No. 2198, Rev. I
ATA Code 27-10

Kit No. 23-4013-1 S

SUBJECT: FLIGHT CONTROLS - INSPECTION AND/OR REPLACEMENT OF AILERON PUSH ROD FORWARD ROD END

SYNOPSIS OF CHANGE: Added note to modify inspection hole location on some airplanes.

VIEW LOOKING FROM BELOW AT LH WING
Figure 1

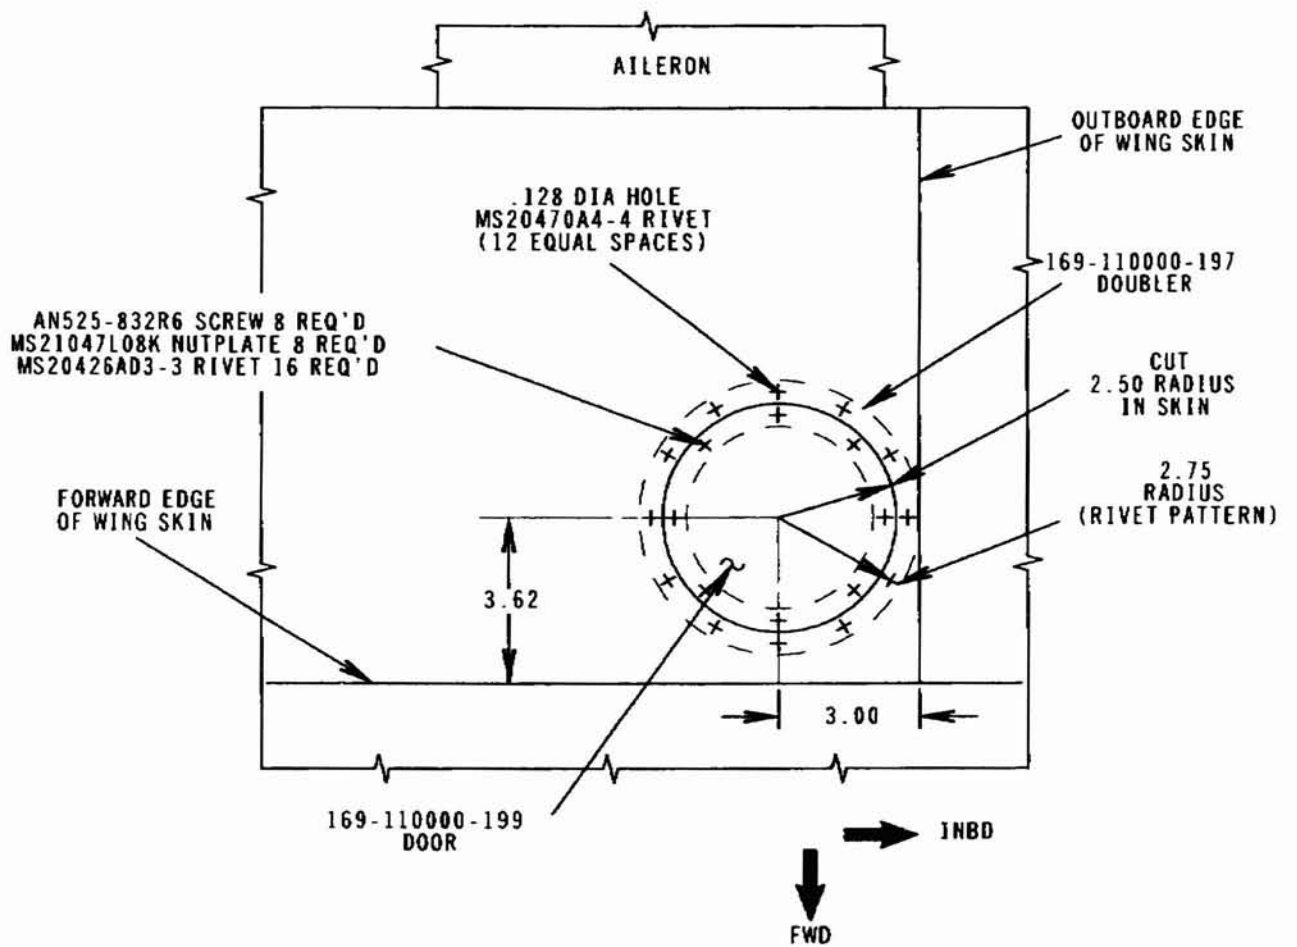
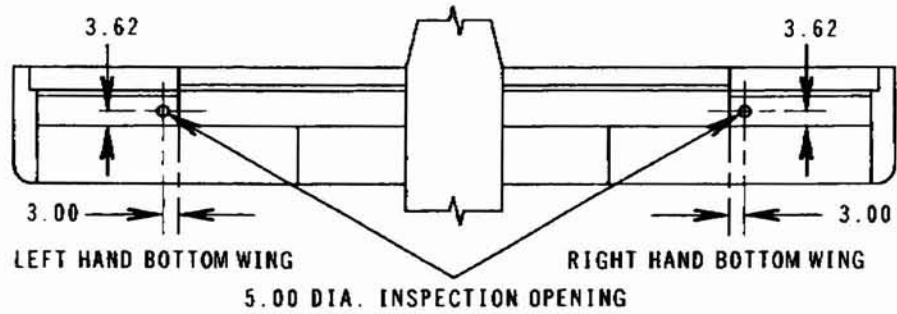
Some airplanes may have an existing 1-3/8 inch diameter hole in the area where the new 5 inch diameter hole is to be cut. If the hole already exists, determine whether the new hole will encompass the existing hole. If so, proceed to Step 2.

1. If it is not possible to include the existing hole in the new hole, locate the center point of the new inspection hole 4.75 inches outboard from the outboard edge of the wing skin, instead of the 3.0 inches shown in Figure 1. (All other dimensions shown in Figure 1 will still be applicable.)

2. Locate a point on the underside of the L.H. wing 3.62 inches from the forward edge of the wing skin and 3.0 inches from the outboard edge of the wing skin as shown in Figure 1. Using this as a center point, lay out a hole 5 inches in diameter.
